Determination 2023/031

Decision by an authority to grant a building consent and issue a code compliance certificate for a small dwelling

251 Priest Road, Eketāhuna

Figure 1: Section showing construction of dwelling (not to scale).

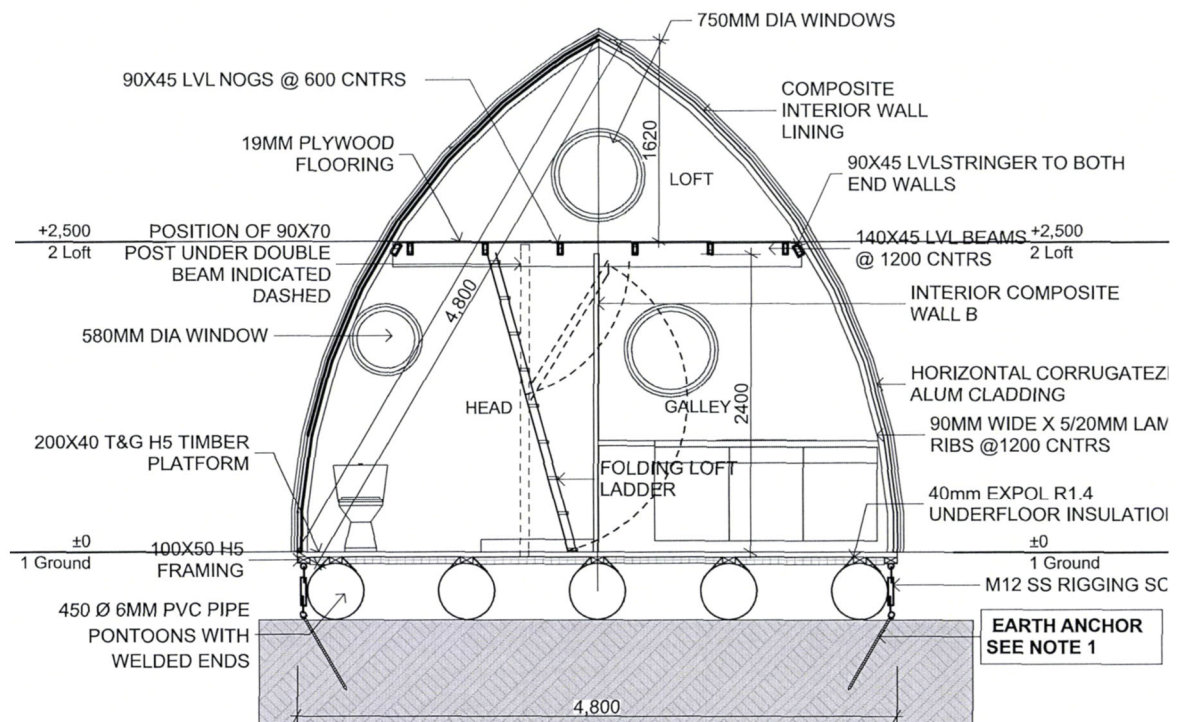
5.2.1. The underfloor insulation was on the approved plans (see Figure 1) but was not installed by the manufacturers. During the consenting process, the authority accepted the manufacturers' explanation that the dwelling did not need to comply with clause H1 because it was off the grid. The insulation was installed as part of the remediation work.

- (9) windows (in terms of moisture ingress)
- 6.21. In addition to the items above, I note that the underfloor insulation specified in the building consent was not installed at the time the code compliance certificate was issued. Regardless of the owner's intention that the dwelling would be off-grid²⁶, the underfloor insulation was required to be installed for compliance with the consented plans.

Figure 3: Rear view of the Ark.

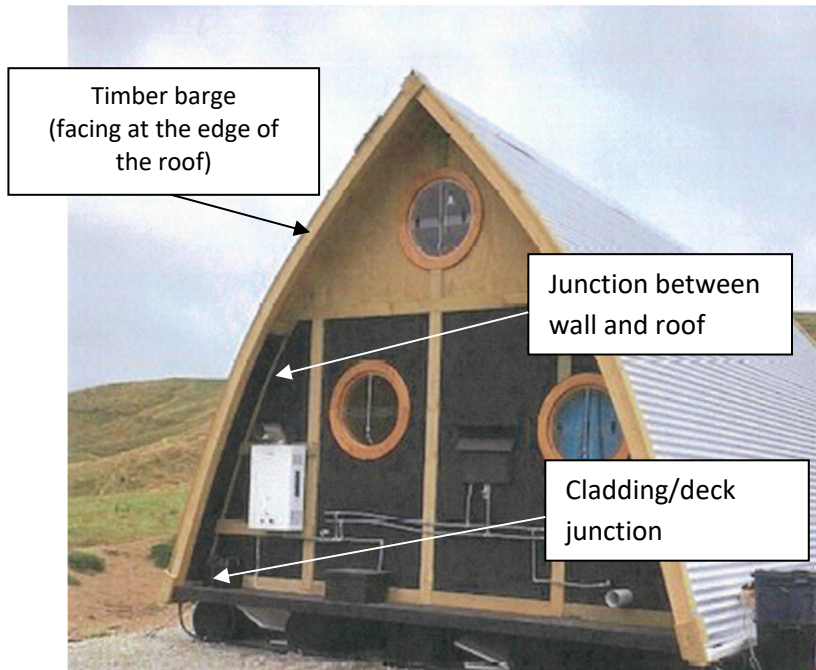
<p><i>Junction between roof and deck (see figure 3)</i></p> <ul style="list-style-type: none"> • There is no detail in the plans shown for the junction between the roof and the deck. • It has been constructed with a timber bead, but I have no information about whether there is any flashing at this junction. • The timber bead will not be sufficient protection from moisture tracking inside the building elements at the junction between the roof/deck and at the point where this meets the wall. • The junction between the roof and deck as-built does not prevent moisture from being absorbed and transferred into the roof and wall system at that joint. Moisture will be absorbed and transferred into the building assembly and damage is likely to occur to the ply lining of the roof assembly along this junction and the untreated internal linings. This does not comply with clause E2.3.2.
Conclusion	<ul style="list-style-type: none"> • As-built, complies with the building consent but the design lacks sufficient detailing for weathertightness. • As-built, does not comply with clause E2.
